Service Technical Information

MODEL NO. XR-MD90 EZ
SUBJECT Noise at tuner function

REF.No. :G - 99 - 055 - E0

DATE :08. NOV . 1999

TUNER C.B PATTERN SIDE

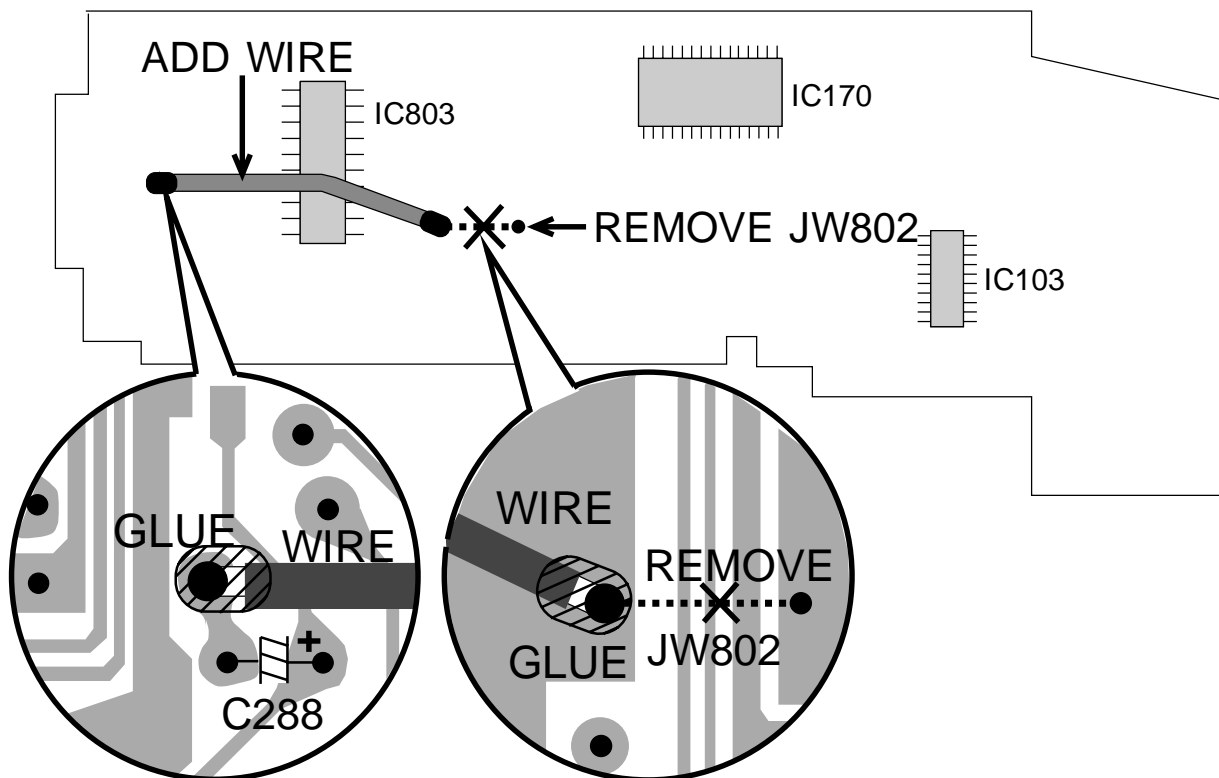
A high-frequency noise is heard with a volume at "0" position in the tuner function mode.
Take the following actions if the problem occurs.

Take the following actions:

1. Remove CABI, TOP AMP in the amplifier block.
2. Remove the JW802 tuner C.B..
3. Solder the wire onto a JW802 pin (one connected to pin 5 of IC803).
4. Solder the other side wire onto a digital ground (minus pin of C288).
5. Lock the both end of the wire with glue.
